## ADDENDUM NO. 2

ARROYO VALLEY HIGH SCHOOL - ATHLETIC FIELD IMPROVEMENTS

DSA No. 04-118542 File No. 36-H7      RCA Job No. 1-78-15

**ASK-02.02**

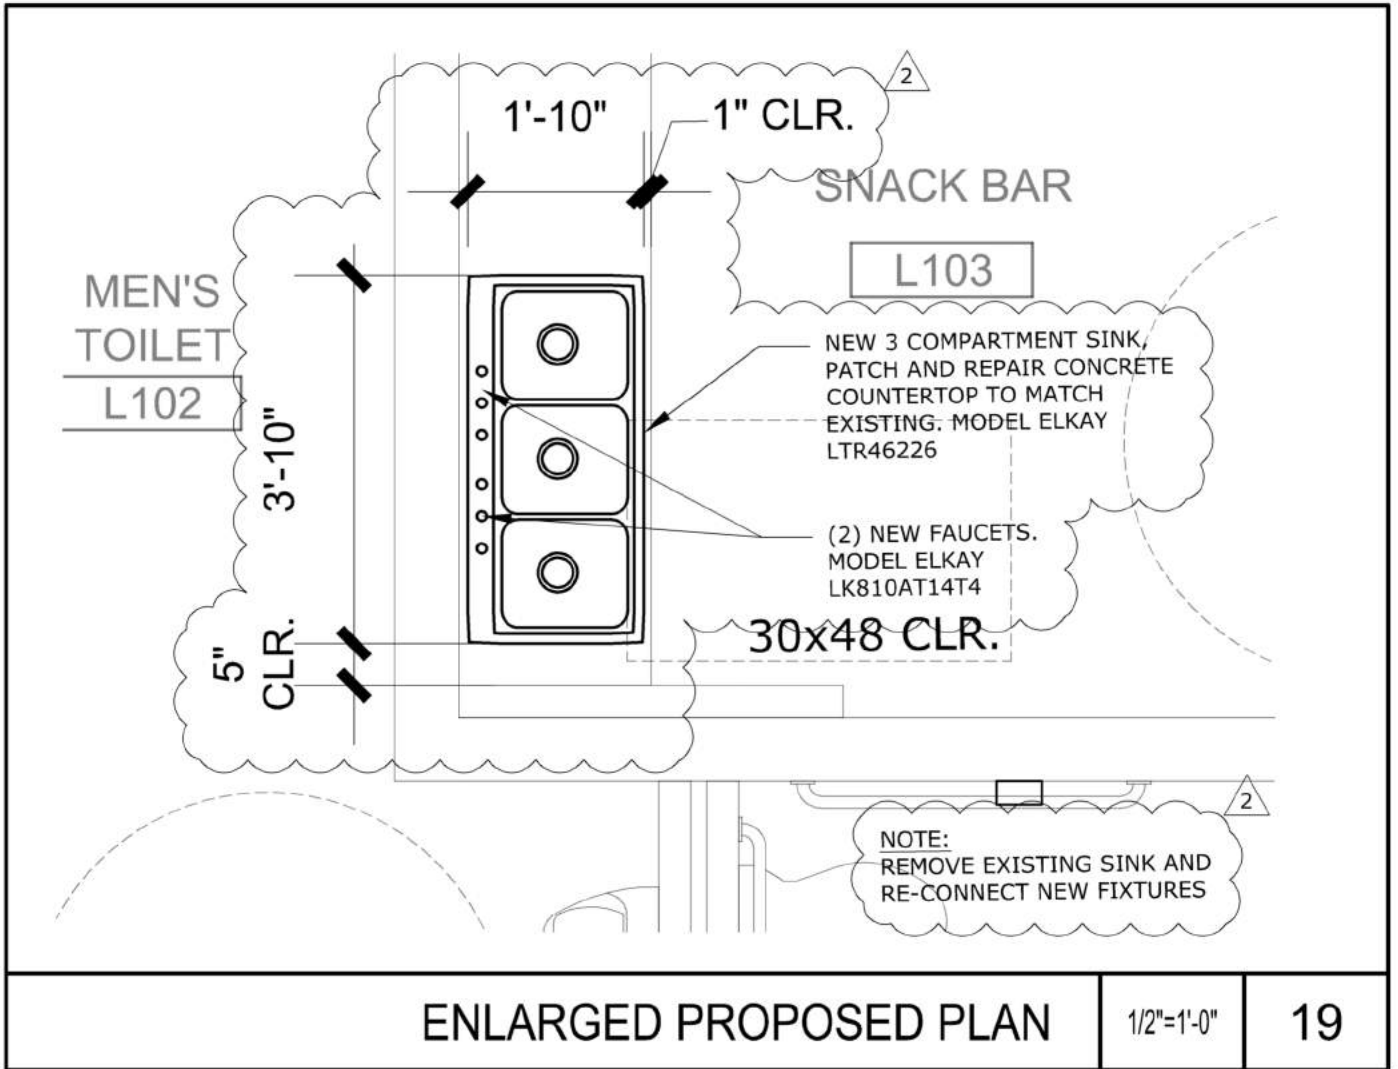
Item No. 2.5      Reference Sheet AS-1.3:  
2.5.1      Add dimensions to Detail 19 enlarged proposed plan per attached Sketch ASK-2.02.  
2.5.2      Revised Keynotes 2.73, 2.74, 2.83 and 2.84 per attached Sketch ASK-2.03.

Sheet #:  
**ASK-02.04**

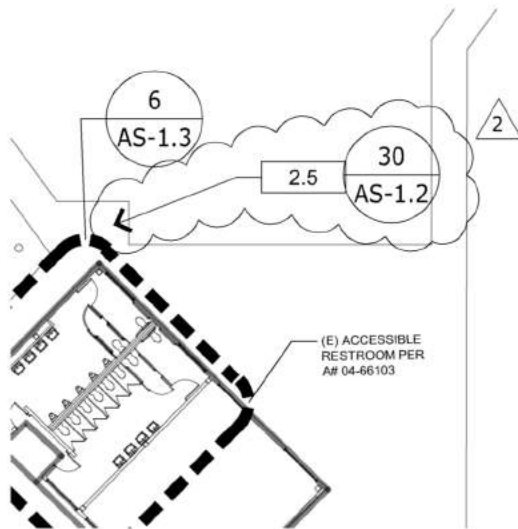
Item No. 2.3      Reference Sheet AS-1.1:  
2.3.1      Keynotes revised per attached Sketch ASK-2.01.  
2.3.2      New concrete extents clarified at batting cage per attached Sketch ASK-2.04.  
2.3.3      Detail callout and Keynote added at restroom per attached Sketch ASK-2.05.  
2.3.4      Replace Detail 2 per attached Sketch ASK-2.06.
